SAS PIER E2 HOT DIP GALVANIZED GRADE BD ANCHOR ROD FAILURES

**AMY REIN WORTH
Commissioner/Chair
Metropolitan Transportation Commission
Oakland, California**

April 21, 2013

**Prepared by Yun Chung
Alameda, California**

(a) Exemplar hardness traverse curve across a 3 inch diameter 4140 steel anchor rod, heat treated to meet the ASTM A354, Grade BD.

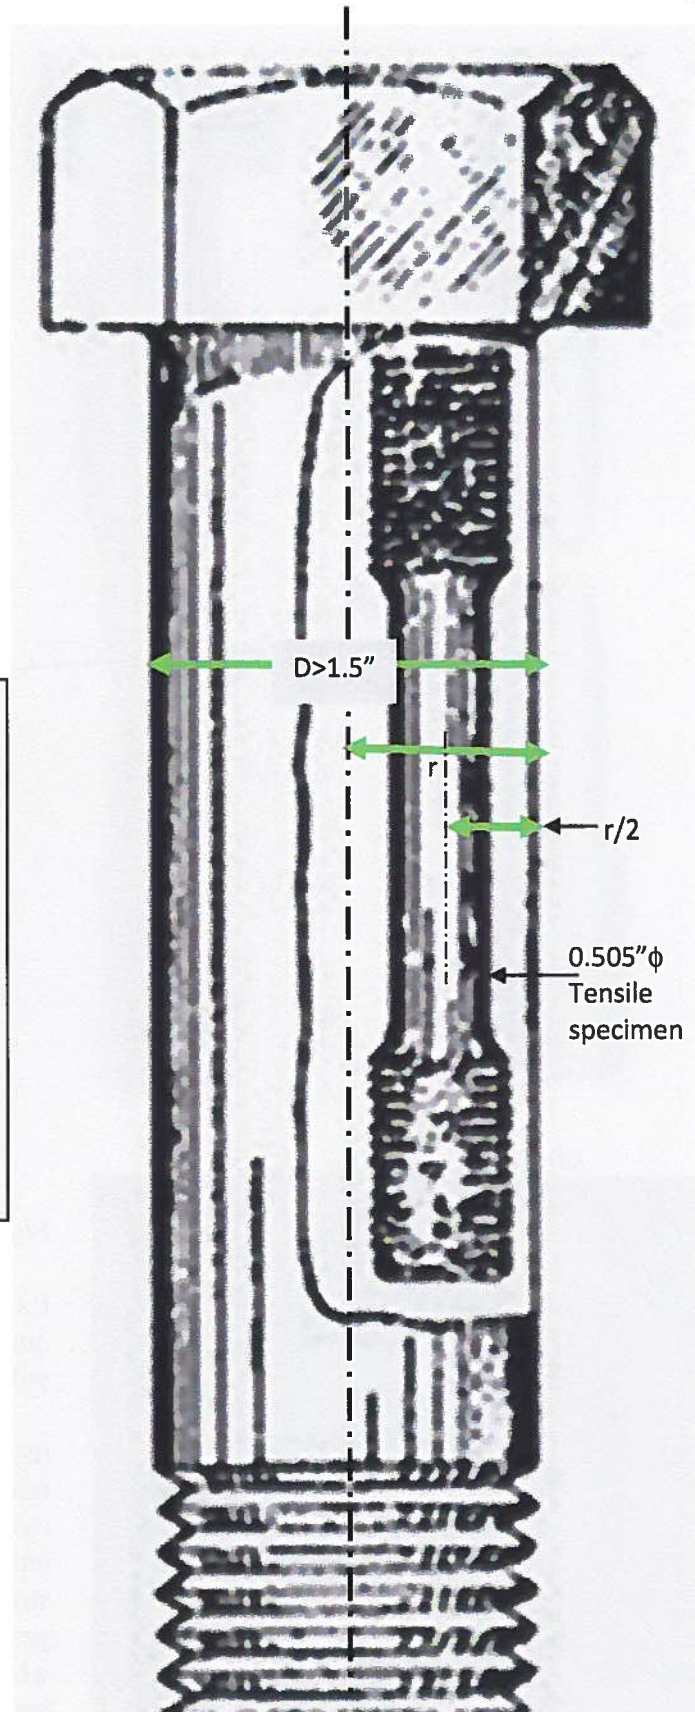
Referring to Figure 10a, a 3-inch diameter 4140 steel anchor rod can have 38-HRC at mid-radius (or $r/2$), and 41-HRC at the surface. The latter would exceed the maximum hardness of 39-HRC for ASTM A354 Gr BD and should not be acceptable. This would be still acceptable, however, under the test methods of ASTM F606,³¹ to which ASTM A354 refers for testing, and also according to ASTM A370.³² Caltrans should have recognized this problem in ASTM specifications and should have made the anchor rod surface as the hardness test location specifically for the Pier E2 anchor rods and required a 100% hardness check at both ends of each anchor rod.

Figure 14 Equo tip hardness test location on exposed threads of anchor rods in Pier E2.

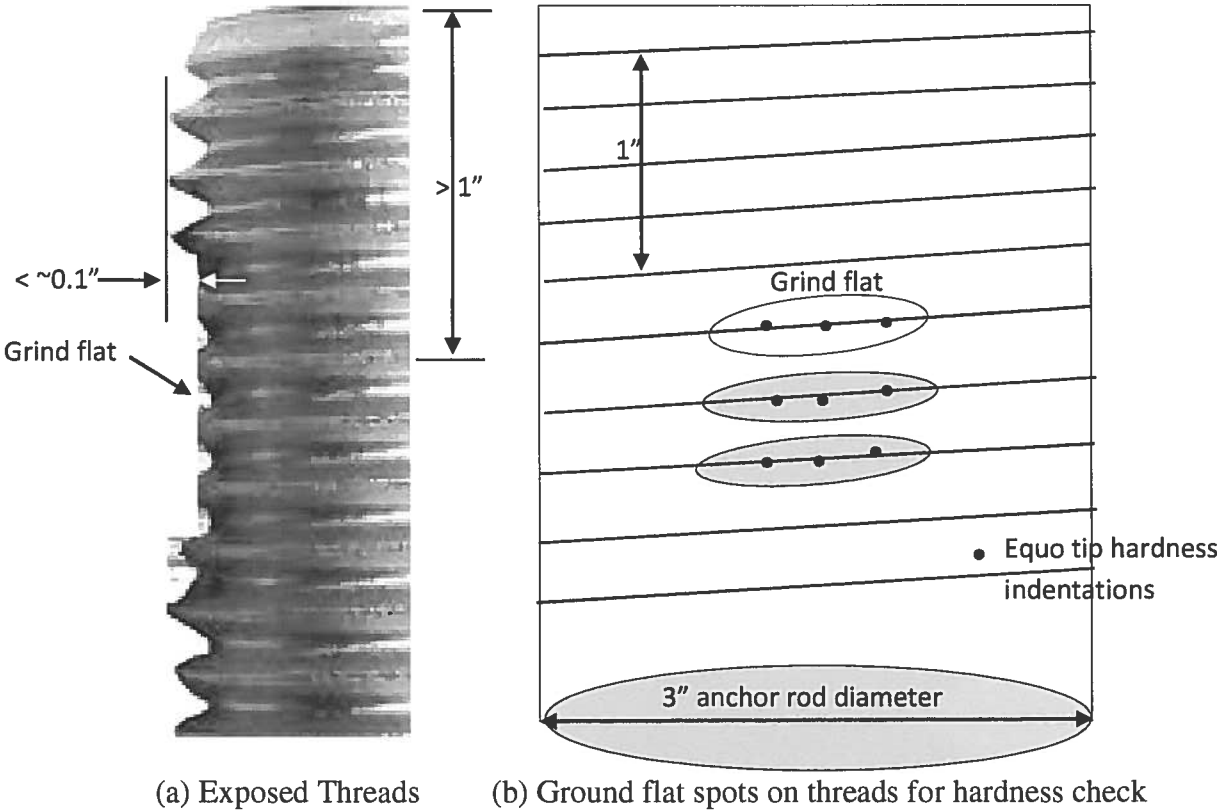
Caltrans should conduct a 100% insitu hardness check on all anchor rods in Pier E2 using Equotip 3 portable hardness tester. The exposed threads outside the nuts may be used for this purpose as illustrated in Figure 14.

- (2) Instead, conduct a 100% in-situ hardness check using an Equotip 3 or other portable hardness tester in the exposed threads outside the nuts, as illustrated in Figure 14. Compile the "surface hardness data" from all the anchor rods, including those that failed, in Pier E2 and evaluate the data with regards to the susceptibility of anchor rods to EHE (environmental hydrogen embrittlement).

- (4) Replace the anchor rods that are high in surface hardness, if possible.
- (5) For replacement anchor rods, establish a maximum hardness limit for the anchor rod surface and require a 100% surface hardness check at both ends of each rod. Either the shank surface next to the end of the threads or three threads near the threaded ends as illustrated in Figure 14 may be used for hardness test using an Equotip 3 or equivalent.

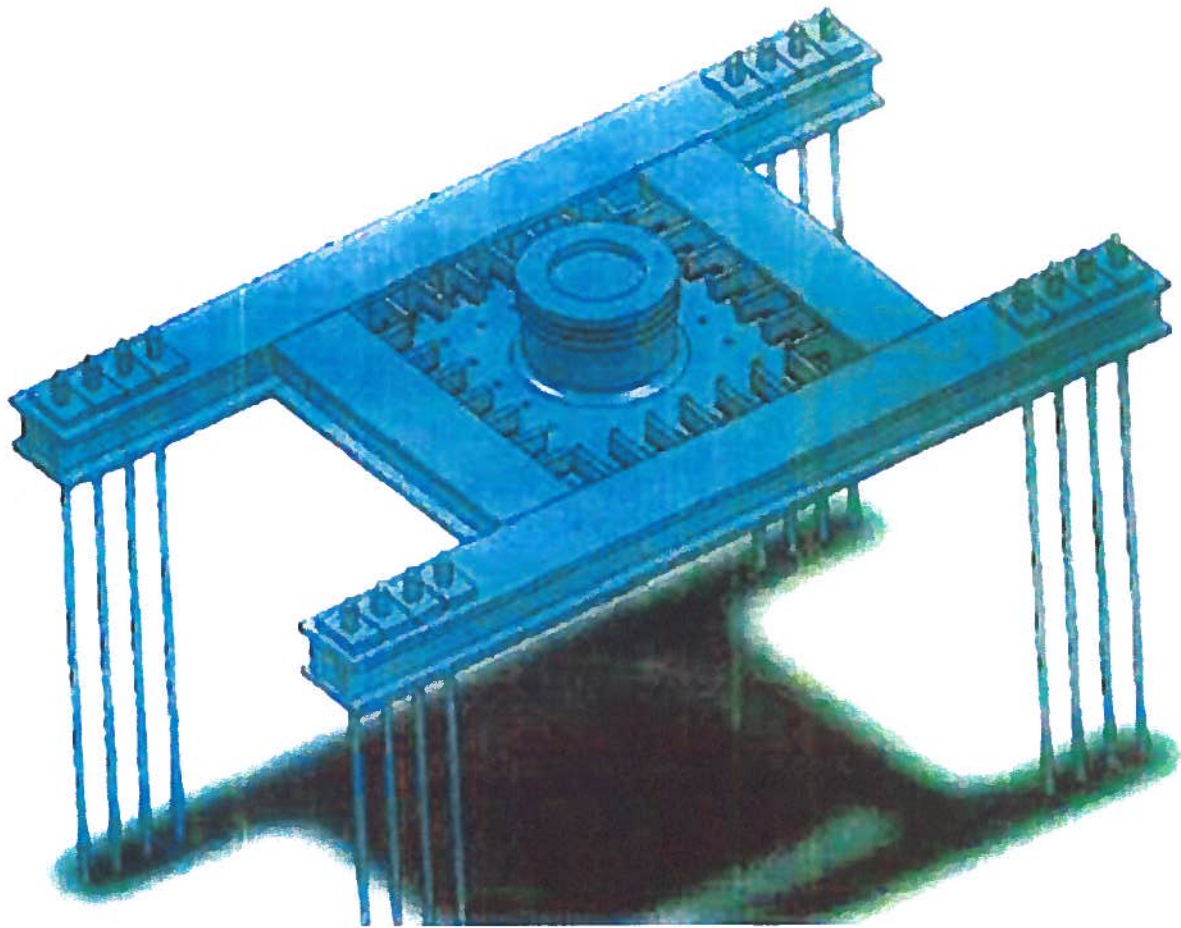
Figure 15 shows a conceptual steel collar design by Caltrans to hold a shear key to the Pier E2 cap beam. Shear Key S1 originally had 48 anchor rods and each one was tensioned to 570-kips or a total load of over 27,000-kips. For S1, 44% of the 48 anchor rods have already failed and rest is questionable if they would also fail due to EHE. Also, out of 16 anchor rods on one side of S1, 9 already failed. The steel beams, fingers attached underside the beams, and the studs to clamp the top and bottom beams together across the Pier E2 cap beam have to be very massive. It will be very difficult to utilize the “fingers” to substitute for the clamping force of the original anchor rods, particularly when the fact that the “fingers” must be a weldable grade is taken into consideration. This approach will not provide an equal substitute for the original design that utilized 3-inch diameter high strength steel anchor rods.
